# Part 5 submission **ACCESS REPORT**

**Reference Number:** 22209

**Site Address:** 9-11 Stapleton Pde, St Marys, NSW

The development is within Penrith City Council LGA and proposes **New Townhouses**

[Image description: Plan of the ground level above shows the provision of Accessible parking spaces]

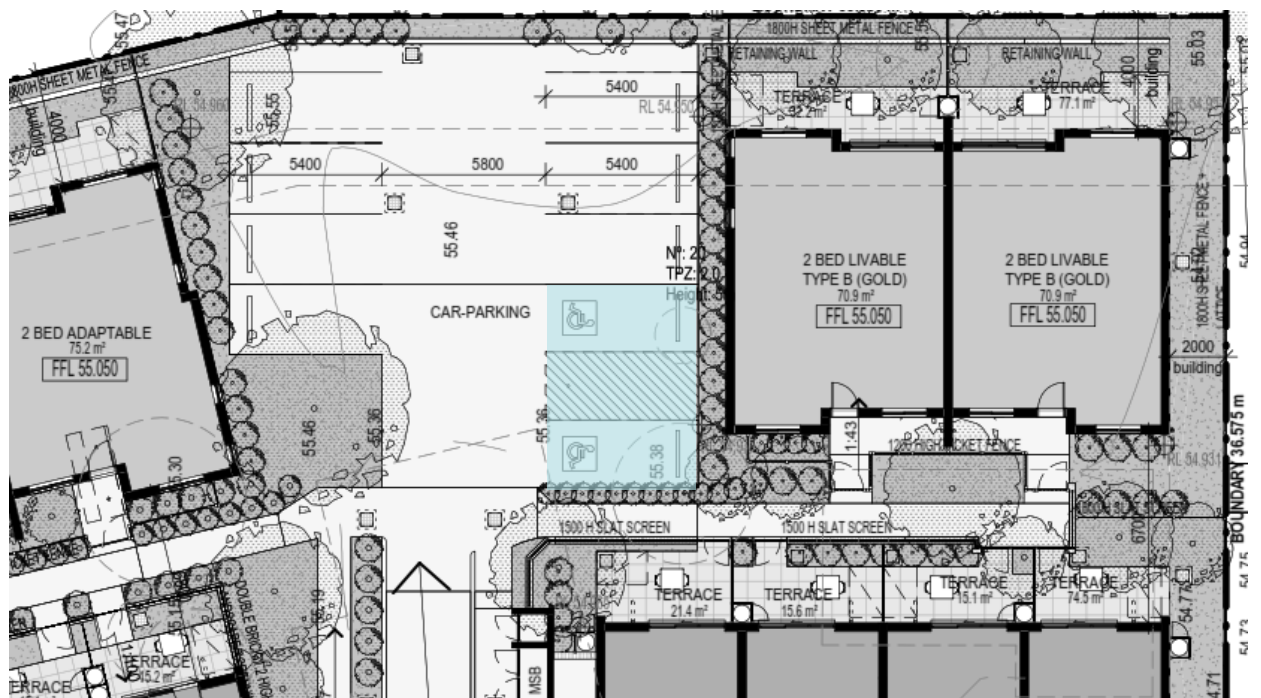
- Dedicated space 2.4Mx5.4M, Shared space 2.4Mx5.4M at the same level
- Slip resistant flooring surface with maximum fall 1:40 in any direction or maximum 1:33 if bituminous and outdoors.

- Central Bollard in shared space at 800+/-50mm from entry point.
- Pavement marking in dedicated space by means of access symbol between 800mm-1000mm high placed on a blue rectangle of maximum 1200mm and between 500mm-600mm from its entry point (marking not required where allocated to an Adaptable unit).

- Minimum headroom of 2.2M at entrances and 2.5M is required over shared space as well as dedicated spaces.
- Non-trafficked area of the shared space to have marking strips at 45°, 150-200mm wide at 200mm-300mm spaces (not required where driveways are used as shared spaces)

- The pavement marking shall have the appropriate slip resistance for the location. This requirement is to be added to the project specifications to ensure compliance.

Details to be verified at CC stage of works.

The following 8 units, 01, 02, 03, 04, 05, 06, 07 and 08 are capable of providing compliance with the features of Silver level of Livable Housing Guidelines as noted in the table below.

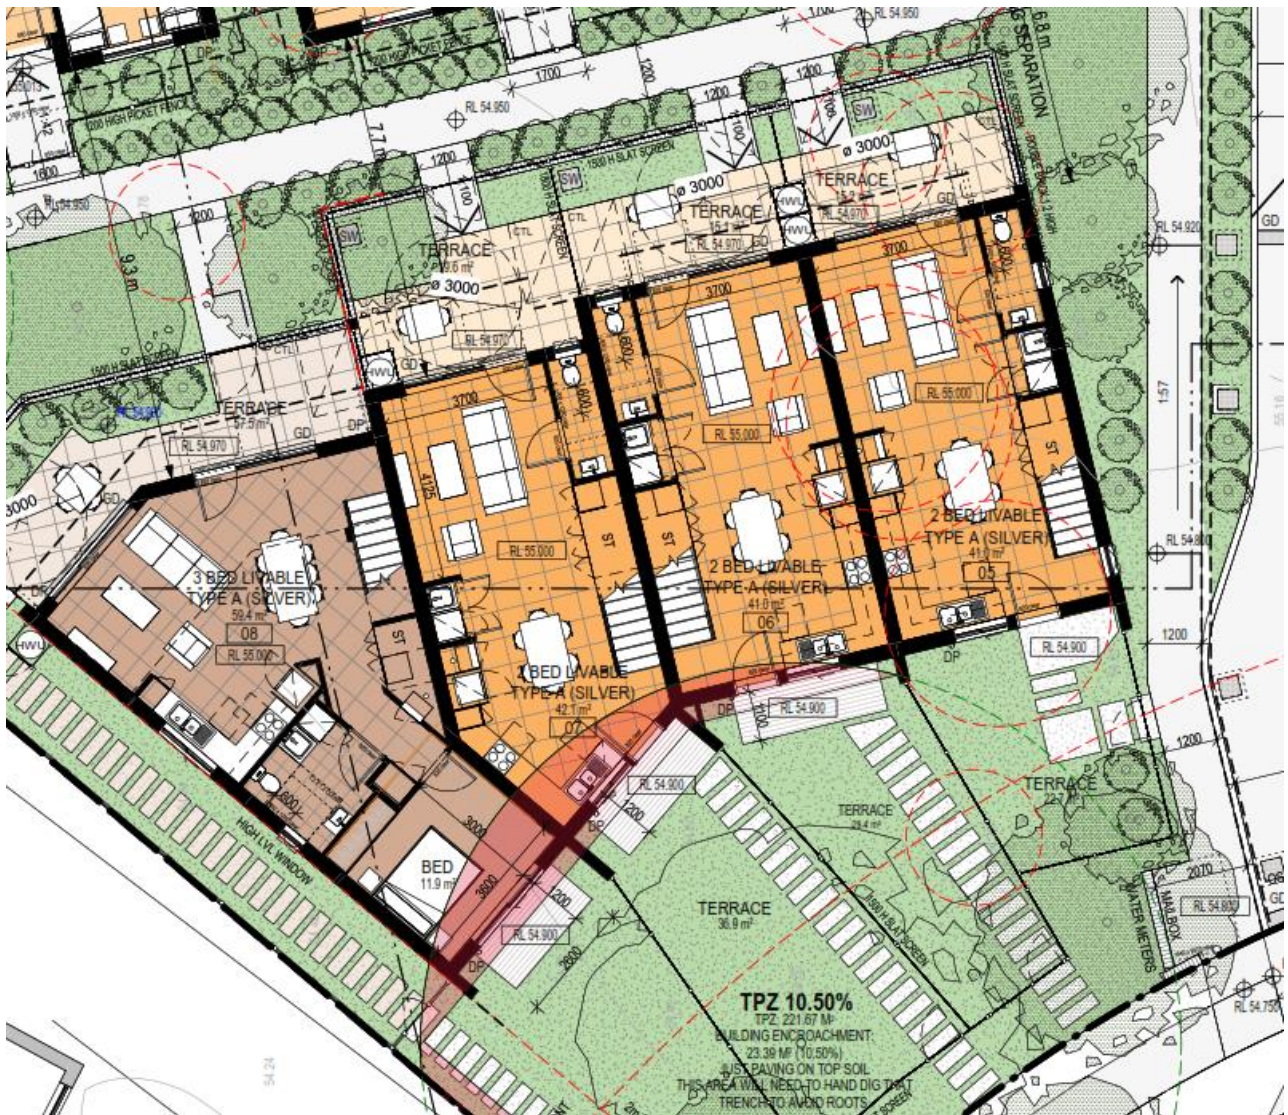
- Note that ALL internal passageways are required to be 1M clear when measured from skirting to skirting so allow for the same.
- Note that the wet areas are to be such that flush transition is available. One way of achieving this is to recess the floor slab.

Units 09, 10, 13 and 14 are capable of providing compliance with the features of Gold level of Livable Housing Guidelines as noted in the table below.

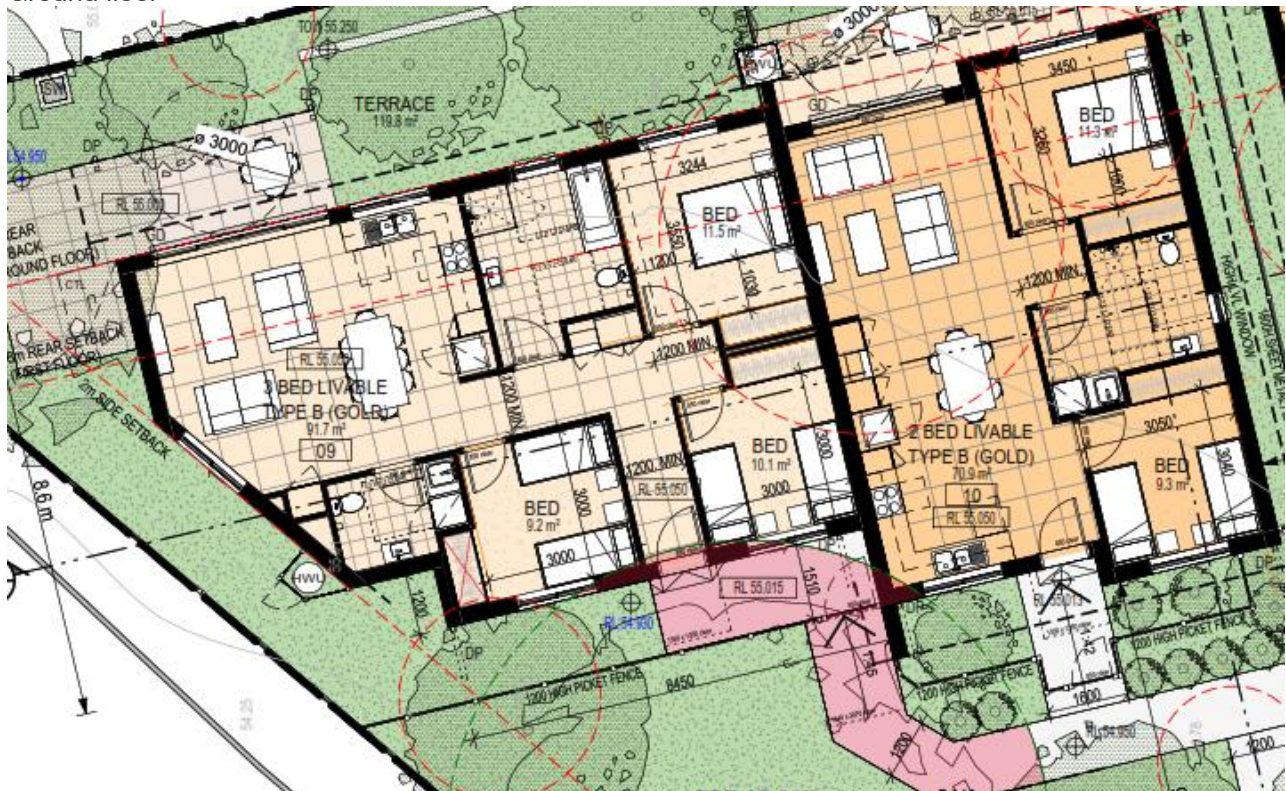
Design Element	Requirements (All dimensions noted are required to be clear of finishes as required under AS1428.1)	Compliance / Comments
<b>1</b> <b>Dwelling Access</b>	<p>a. Provide a safe and continuous 1.1M clear width pathway from front site boundary to an entry door to the dwelling.</p> <p>b. Path including any ramps and walkways to have no steps, even firm, slip-resistant surface, max 1:40 crossfall, max slope of 1:14 with landings of 1.2M every 9M and landings every 15M for 1:20 walkways. 1.1M clear width of ramps are required.</p> <p>c. Pathway may be provided via an associated car parking in which case the car parking space to be</p> <ul style="list-style-type: none"> <li>▪ 3200 (width) x5400 (length),</li> <li>▪ even, firm and slip resistant, level surface of 1:40 max grade and</li> <li>▪ 1:33 max grade for bitumen</li> <li>▪ a vertical clearance over the parking space of at least 2500mm; and</li> <li>▪ a covered parking space to ensure protection from the weather.</li> </ul> <p>d. Step ramp may be provided at an entrance doorway. The step ramp to be max 190mm height, max 1:10 grade, max 1900mm length. 1.1M clear width of ramps are required.</p> <p>e. Level landings of 1200mm are required exclusive of the swing of the door or gate and to be provided at the head and foot of the ramp.</p>	<p>Complies. Details to be verified at CC stage of works</p> <p>N/A.</p> <p>N/A</p> <p>N/A</p>

<b>2</b> <b>Dwelling entry</b>	<p>a. Dwelling Entry should provide an entrance door with</p> <ul style="list-style-type: none"> <li>i. min <b>clear</b> opening width of door to be 850mm</li> <li>ii. Step free threshold of max 5mm with rounded or beveled lip</li> <li>iii. reasonable shelter from the weather</li> </ul> <p>b. Level landing of 1350x1350mm at step-free entrance door on the arrival / external side of the entrance door.</p> <p>c. Max permissible threshold is less than 56mm where provided with a 1:8 grade threshold ramp.</p> <p>d. Entrance to be connected to a pathway (specified under Element 1)</p> <ul style="list-style-type: none"> <li>i. <b>Note:</b> The entrance to incorporate waterproofing and termite</li> <li>ii. management requirements as specified in the NCC</li> </ul>	<p>Complies. Details to be verified at CC stage of works</p> <p>Complies with spatial requirements. Details to be verified at CC stage of works</p> <p>N/A</p> <p>Complies. Details to be verified at CC stage of works</p>
